Lake Merritt Station Area Plan

Final Environmental Impact Report

July 2014

Prepared for the **City of Oakland** by

Fig. 3.8-2
Historic Resources & Opportunity Sites

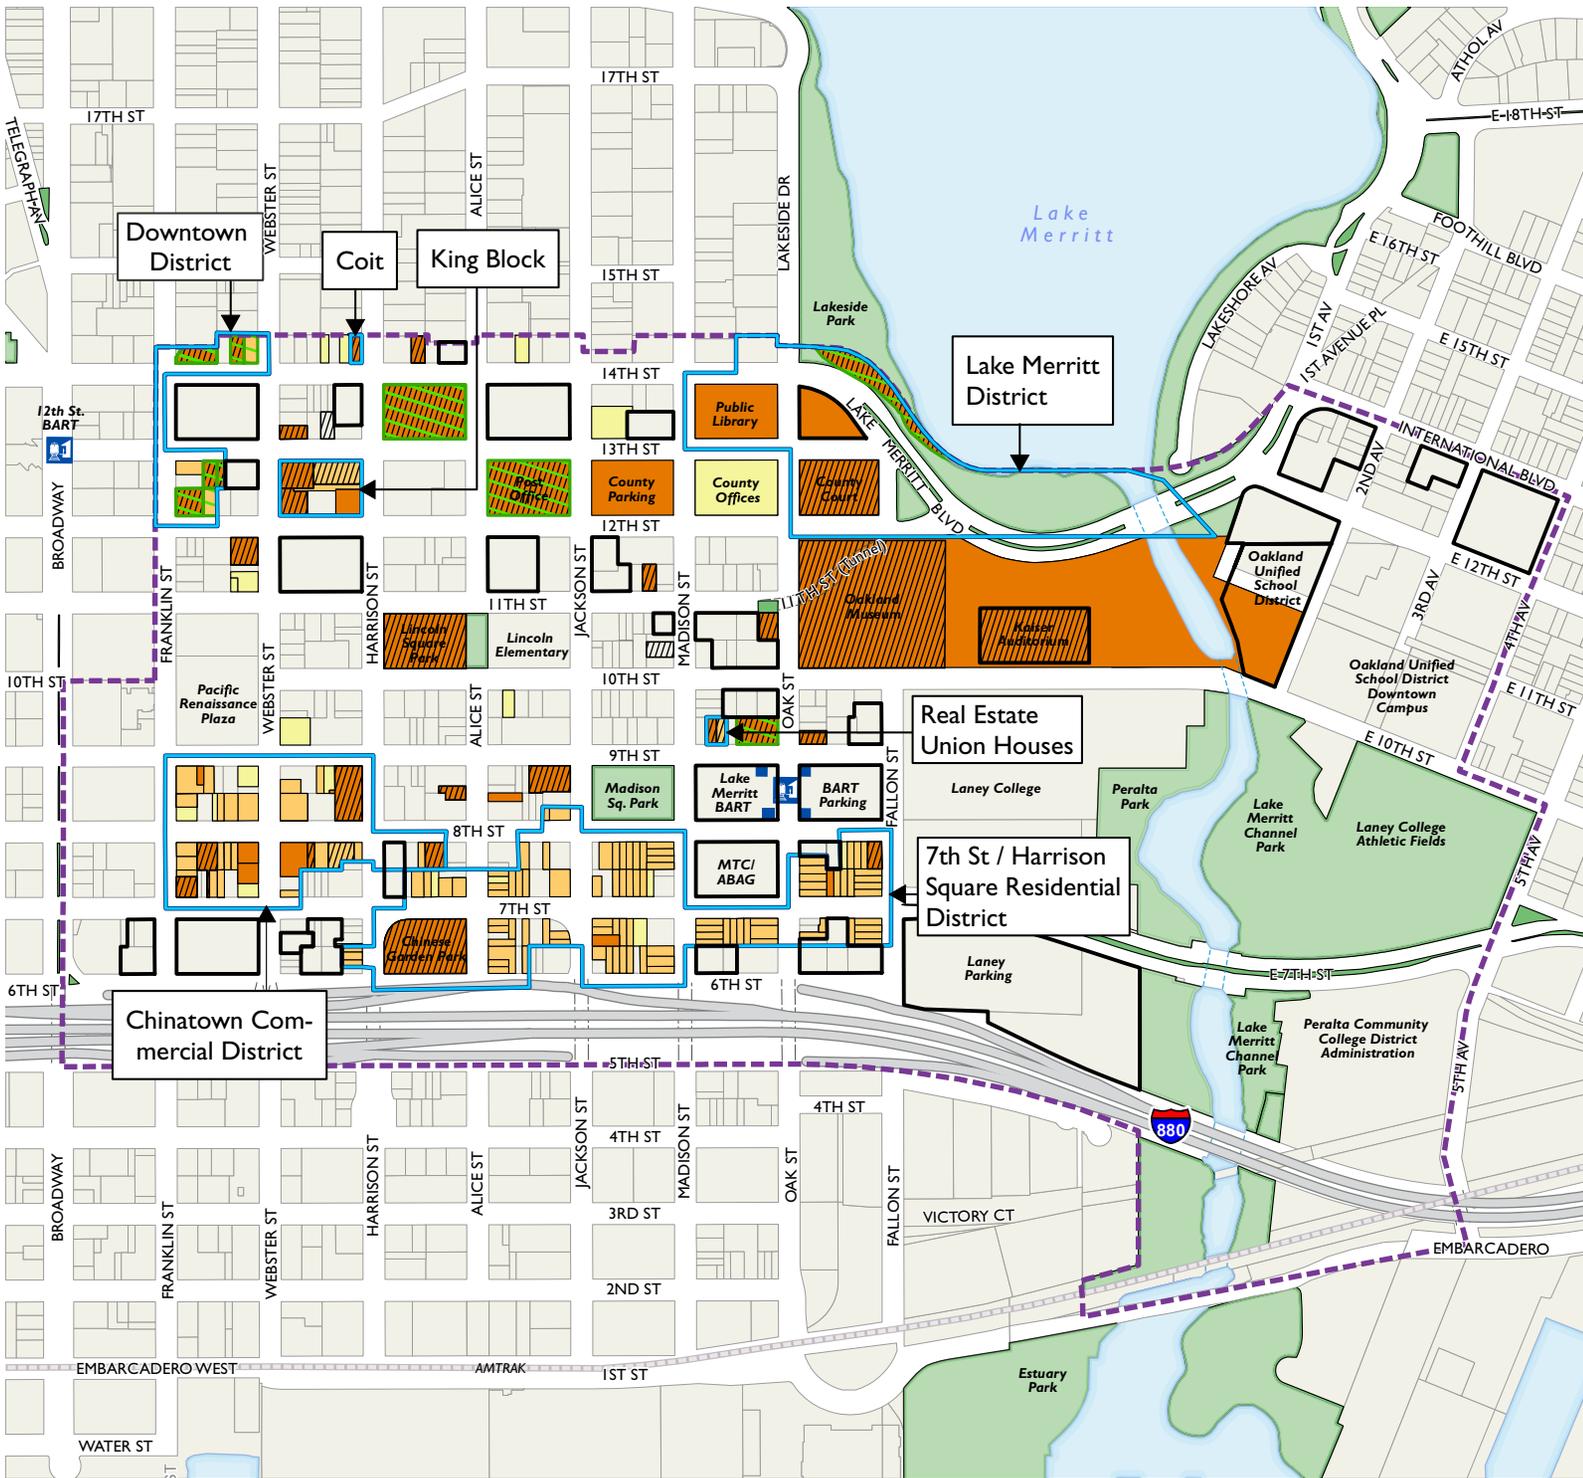
Figure 3.8-2 Historic Resources & Opportunity Sites is revised, using a more distinct symbology for sites listed on the State and/or National Register, and to identify Fire Alarm Building site.

- C1-6: Figure 3.8-1: Historic Resources and Figure 3.8-2: Historic Resources & Opportunity Sites are updated, using a different symbol to denote State and/or National Register-listed properties.

Figure 3.8-3
Height Areas and Historic
Areas of Primary
Importance

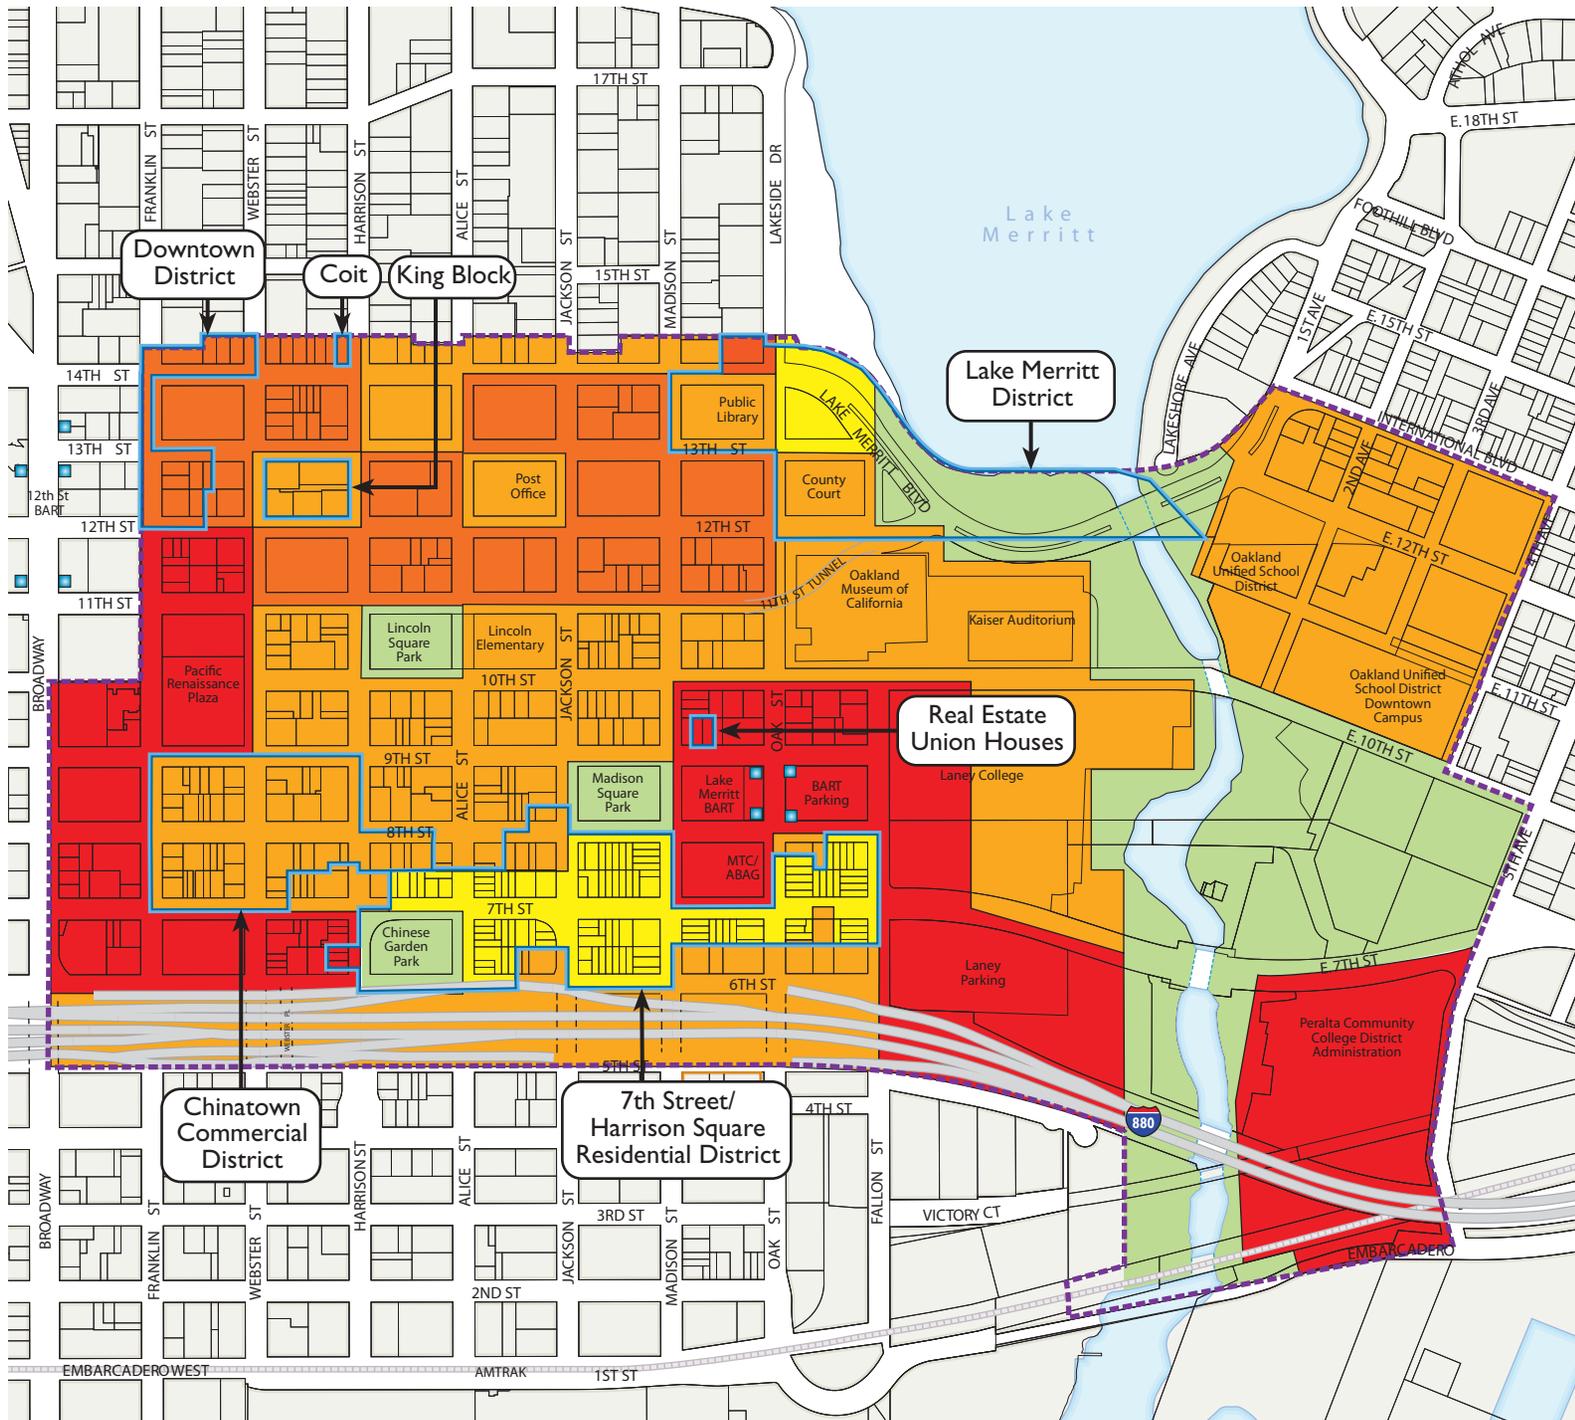
Figure 3.8-3: Height Areas and Historic Areas of Primary Importance is revised to reflect the Plan changes to Height Areas described in Chapter 2 of this FEIR.

Figure 3.13-2
Contaminated Sites,
Opportunity Sites,
and Schools

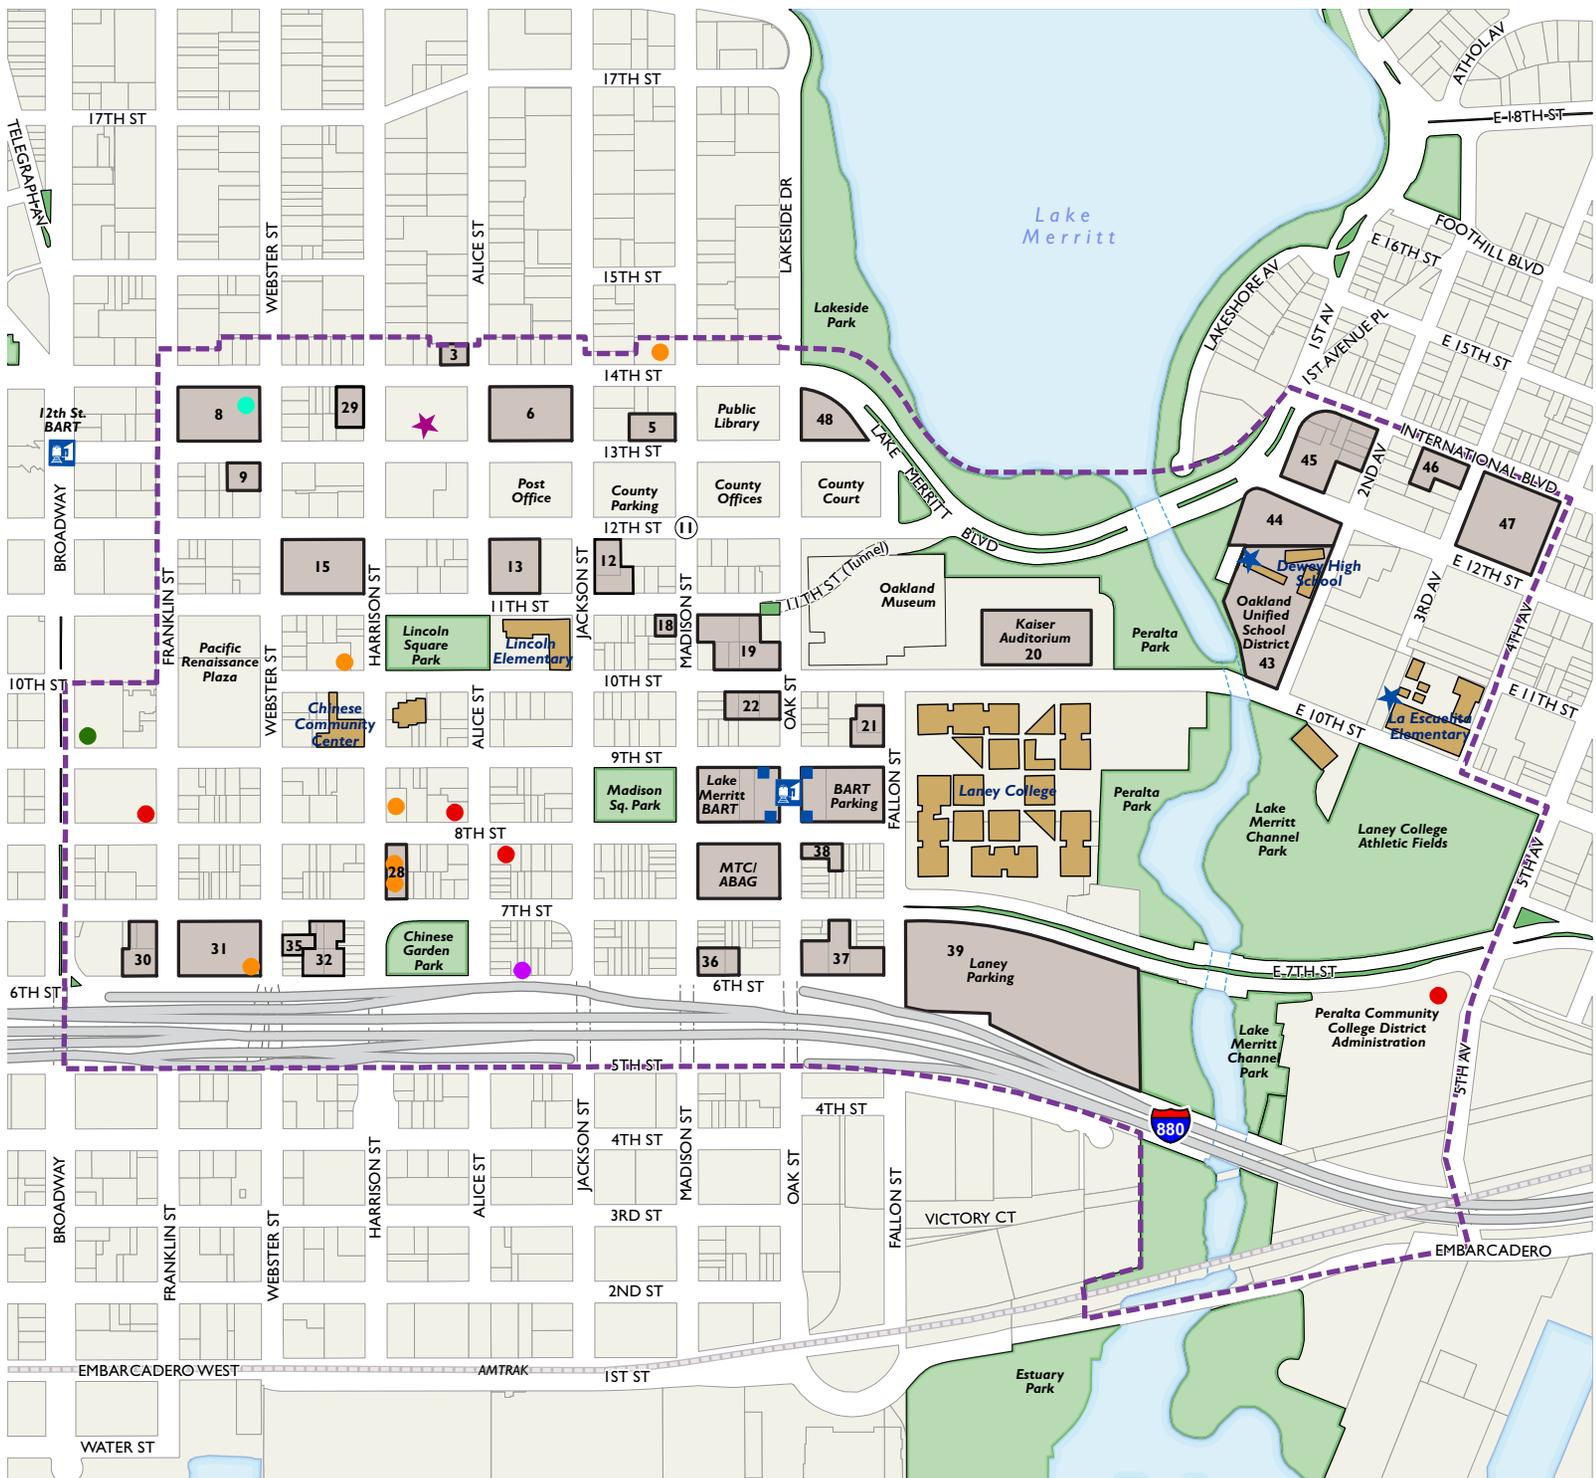
Figure 3.13-2 Contaminated Sites, Opportunity Sites, and Schools, is revised to identify Fire Alarm Building site as Opportunity Site #48.
